INITIAL FIRE SAFETY INSPECTION REPORT

Crown Wears (Pvt.) Ltd. (Extension)

RSC ID: 26009

Date: 04-Mar-2025

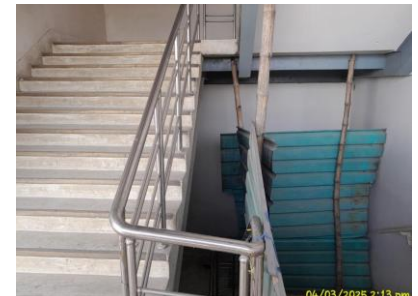
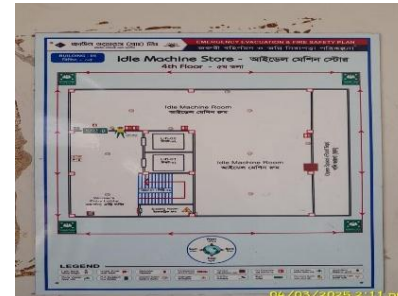
F-09	Means of Egress	A single exit has been provided from the Idle machine store, which exceeds the allowable travel distance limit, as only stair 3 (North-East) is accessible out of the six available stairs from the mentioned areas. Location(s): 4th & 5th floor, Building-5.	The number of means of egress from any floor, story, or portion thereof shall not be less than 2 except where a single exit is permitted by RSC Technical Guidelines (Standard) 6.6.2.	Within 3 months
------	-----------------	---	--	-----------------

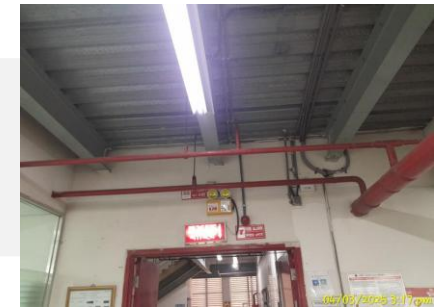
F-27	Inspection, Testing & Maintenance (ITM of FADS)	Inspection, testing, and maintenance for the fire alarm system is not in accordance with NFPA 72 and The RSC Technical Guidelines (Standard). Location(s): Building-5.	Inspect, test and maintain the fire alarm system and keep written records on-site, in accordance with NFPA 72 and The RSC Technical Guidelines (Standard) and keep written records on-site.	Within 1 month (after installation)
F-28	Fire Protection System (Sprinkler System)	The existing building has an occupied floor height (71 feet) greater than 10 meters (33 feet), and a fire sprinkler system is under installation throughout the building in place of the detection system. So, an automatic fire sprinkler system is mandatory for this building. Location(s): Building-5.	Submit the sprinkler system drawing to RSC for review. Once the design is reviewed, install/ modify the sprinkler system throughout the building in accordance with review comments, RSC Technical Guidelines, and NFPA 13, 14, 20, 22, & 24. After installation, the owner shall conduct internal testing and commissioning and then contact the RSC for witness of final acceptance testing.	Design Review within 2 months and installation within 4 months.

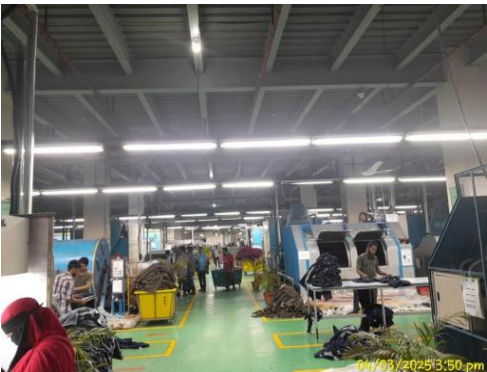
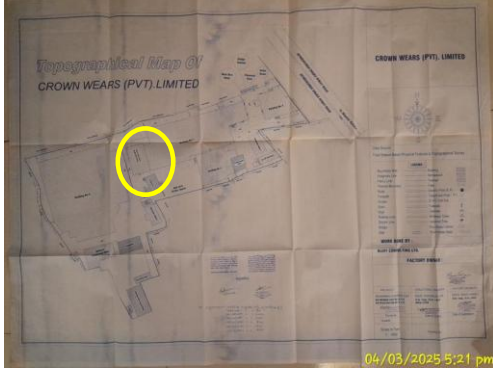
F-35	Fire Rated Construction	The main structural elements of the Production Building-5 are constructed of steel elements, which are non-rated and were found in exposed condition without any fire protection. As per RSC Technical Guideline and BNBC 2006, The Fire rating of the structure requires to be confirmed as per BNBC 2006. Location(s): Production Building-5.	The "Ministry of Housing and Public Works" has issued a resolution based on the recommendations from the House Building Research Institute (HBRI) and the Public Works Department (PWD) to assess structural fire protection requirements of steel buildings (unprotected non-combustible construction type) according to BNBC 2020. The construction type shall confirm to be in accordance with BNBC 2020 Part-3, Table 3.1.7. Ensure fire resistive rated construction following Table 3.3.1 (a) Part 3 Section-3, Table 3.2.2 and Table 3.2.3 Part 3 Section 2 and Table 4.1.1 from BNBC 2020 Part 4 Section 1. Provide design philosophy to determine the construction type as per BNBC 2020. If any construction rating requires, Consult a qualified fire protection engineer to achieve the require fire rating.	Within 6 months

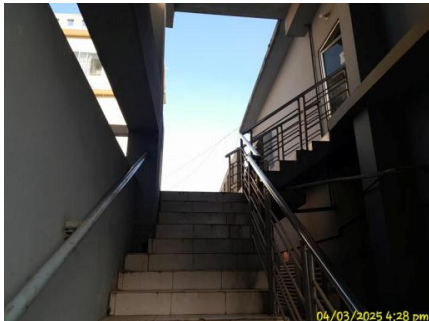
F-44	Mean of Egress	Stair width was found to be less than 1.5m (60 inches), available 40 inches. Location: Substation Building-2.	Stairs shall have a minimum clear width of 1.5 m (60 in.) for all industrial occupancies	Within 3 months
